EPC PACKAGE FOR LARA SUPER THERMAL POWER PROJECT, STAGE-II (2x800 MW)
Amendment No. 03 to Technical Specifications Section-VI of Bidding Document No.: CS-9587-001R-2

Doc. No.: CS-9587-001R-2-TECH AMDT- 03	LARA SUPER THERMAL POWER PROJECT STAGE-II (2X800 MW)	Amendment No. 03 to Technical Specifications Section-VI
--	--	---

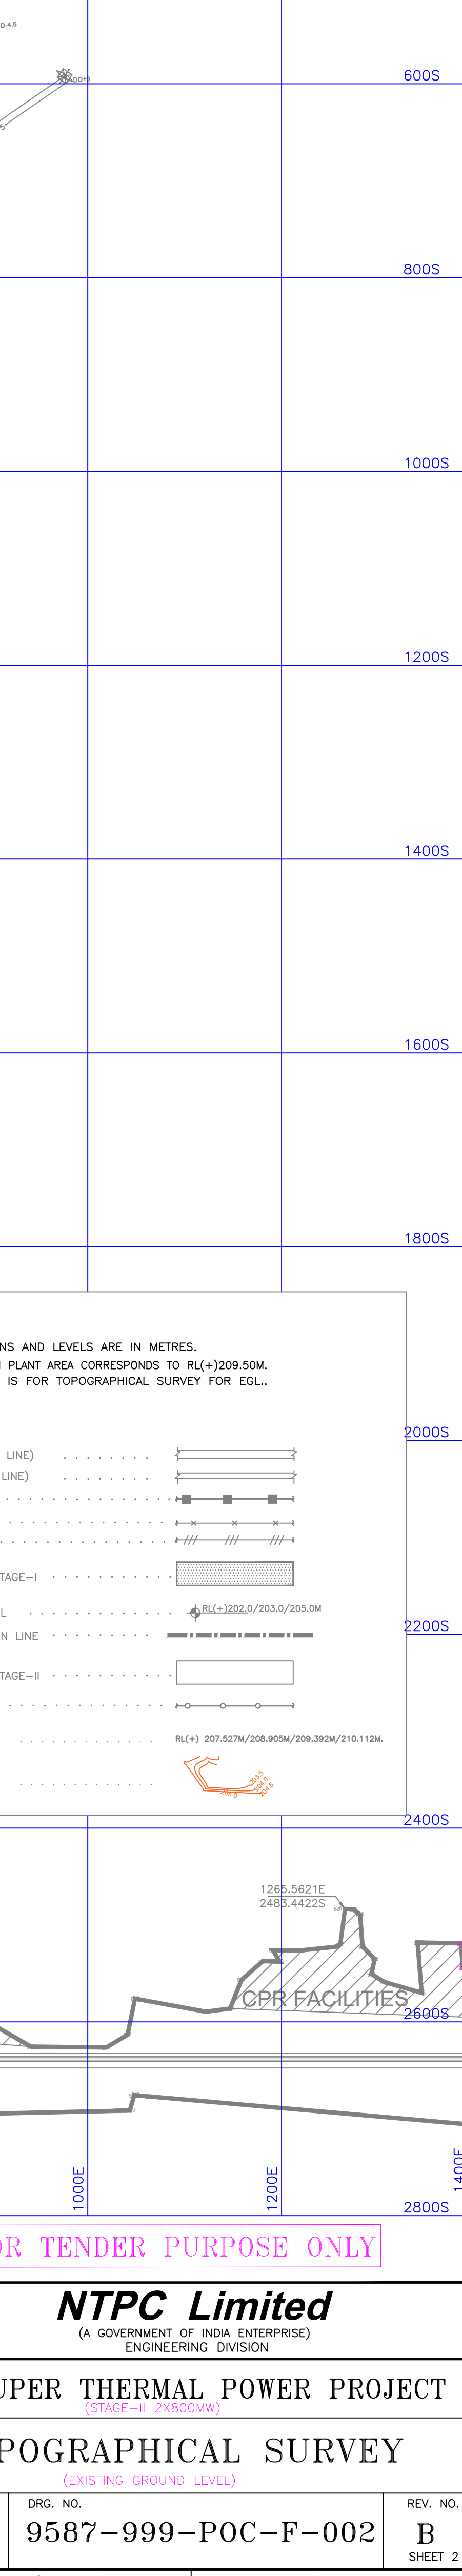
S. No.	SPECIFICATION REFERENCE				Instead of	Read as
	Section / Part	Sub-Section	Clause No.	Page No.		
D3-01	Amendme nt no 2 to Technical specificat ion. D2-16		TENDER DRAWINGS		9587-999-POC-F-001-Rev-A	9587-999-POC-F-001-Rev-B
					9587-999-POC-F-002-Rev-A Sheet 1	9587-999-POC-F-002-Rev-B Sheet 1
					9587-999-POC-F-002-Rev-A Sheet 2	9587-999-POC-F-002-Rev-B Sheet 2
					9587-001-POC-A-003-Rev-A	9587-001-POC-A-003-Rev-B
					9587-001-POC-A-004-Rev-A	9587-001-POC-A-004-Rev-B
					9587-001-POC-A-005-Rev-A	9587-001-POC-A-005-Rev-B
					9587-001-POC-A-06-Rev-A	9587-001-POC-A-06-Rev-B
D3-02	Amendme nt no 2 to Technical specificat ion. D2-01				DEVELOPMENT OF LAYDOWN AREA Bidder shall use a lay down area as shown in GLP. One area marked in GLP totalling 75 acres(approx.) are identified as laydown/preassembly area. Further, bidder to note that this 75 acres of land shall be converted into reservoir by bidder. Fencing of the laydown area in the area marked for laydown is also in Bidder's Scope	DEVELOPMENT OF LAYDOWN AREA Bidder shall use a lay down area as shown in GLP. One area marked in GLP totalling 75 acres(approx.) are identified as laydown/preassembly area. Additional area of approximately 25 acres shall be allocated within plant premises during construction stage. Bidder to manage the allocated laydown area in reservoir area such that it can be vacated in phased manner for construction of reservoir as per project schedule. This 75 acres of land shall be converted into reservoir by bidder. Fencing of the laydown area in the area marked for laydown is also in Bidder's Scope

DETAIL'S OF ROADS

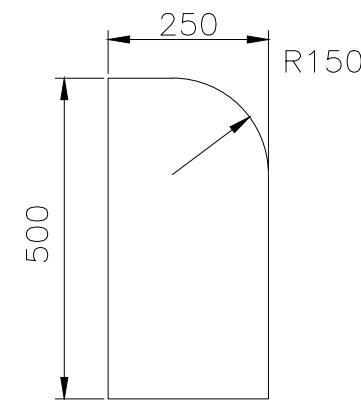
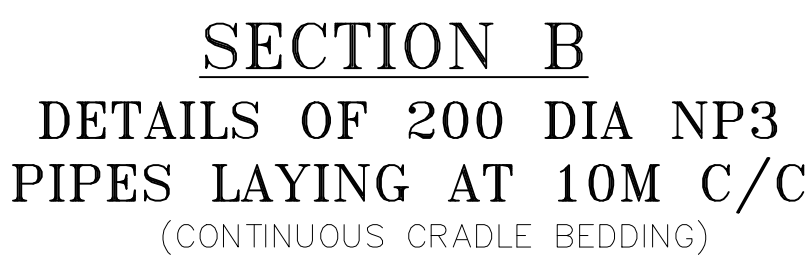
D3-13	VI/B	D-1-5	5.10.00	40 OF 86	Roads All roads shall be of rigid pavements unless otherwise specified. Rigid pavements shall be constructed with Geopolymer concrete. Concrete road/pavement or rigid pavement, mentioned	Roads All roads shall be of rigid pavements unless otherwise specified. Rigid pavements shall be constructed with Geopolymer concrete. Concrete road/pavement or rigid pavement, mentioned in specification, shall mean road.....

S. No.	SPECIFICATION REFERENCE				Instead of	Read as
	Section Part	Sub-Section	Clause No.	Page No.		
					in specification, shall mean road..... All service and utility lines like fire water line, sewerage line, electric cables line etc. crossing the road shall be taken through NP3 class RCC Hume pipe. Hume pipe shall be laid before road work so that the road shall not be damaged. Construction of road work shall be as per priorities given in Tender drawing 'Layout of Road Drawing'.	All service and utility lines like fire water line, sewerage line, electric cables line etc. crossing the road shall be taken through NP3 class RCC Hume pipe. Hume pipe shall be laid before road work so that the road shall not be damaged. Turning Circle radius adequate for 16 Wheel Truck shall be provided at all relevant points including approach (Entry/Exit) and access road for Truck movement at loading/unloading/weighment facilities of Limestone, Gypsum, Ash, Biomass for efficient and safe movement of truck. Construction of road work shall be as per priorities given in Tender drawing 'Layout of Road Drawing'.
